TECHNICAL MEMORANDUM

Utah Coal Regulatory Program

RE: Water Monitoring Modification, Canyon Fuel Company LLC, Skyline Mine, C007/0005, Task # 3897

Potentiometric Water Levels in Section 4

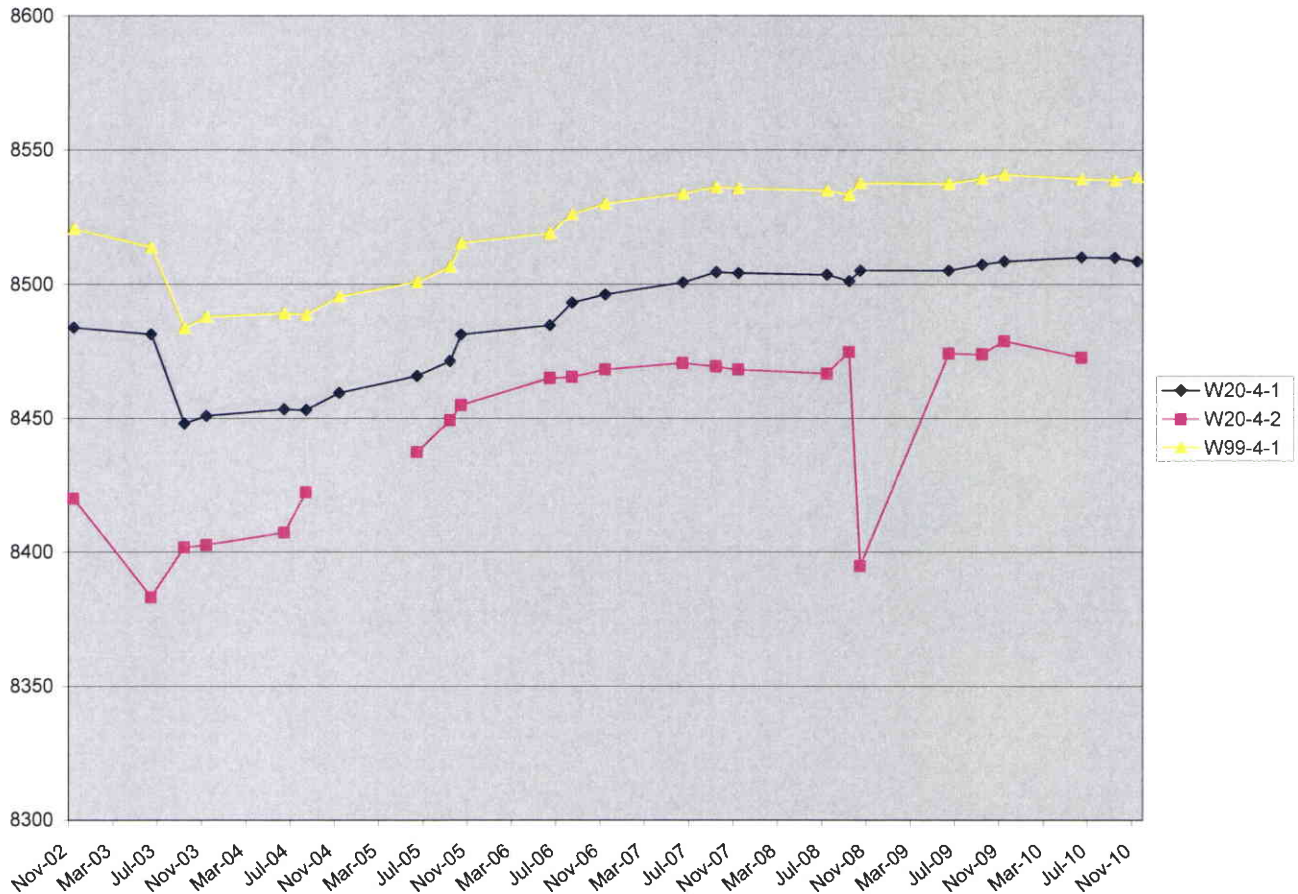
The Permittee has indicated that groundwater monitoring well W20-4-2 is no longer functional because it has been breached approximately 700 feet below the surface and approximately 375 feet above where the last water level was collected. This well is located in Section 4, Township 12S R6E. There are two additional wells (20-4-1 and 99-4-1) also located in Section 4 adjacent to a stream in Boulger Canyon measured for water level only on a quarterly basis. These wells are separated from W20-4-2 by approximately 3,000 feet of distance and elevations between 683-712 feet below W20-4-2. The chart on the following page was plotted to show the water levels in each of these wells.

As can be seen on the above chart, the potentiometric water surface appears to follow a general trend in all three wells indicating that all three wells measure ground water originating from the same aquifer. Based on this chart, it appears that collecting water level data from the nearby two wells in Section 4 would be representative of groundwater in this area. Therefore, there will not be any additional need for a replacement well for W20-4-2.

As a result of the breach in the casing, the Permittee has removed groundwater monitoring well W20-4-2 from Table 2.3.7-1, page 2-36a.
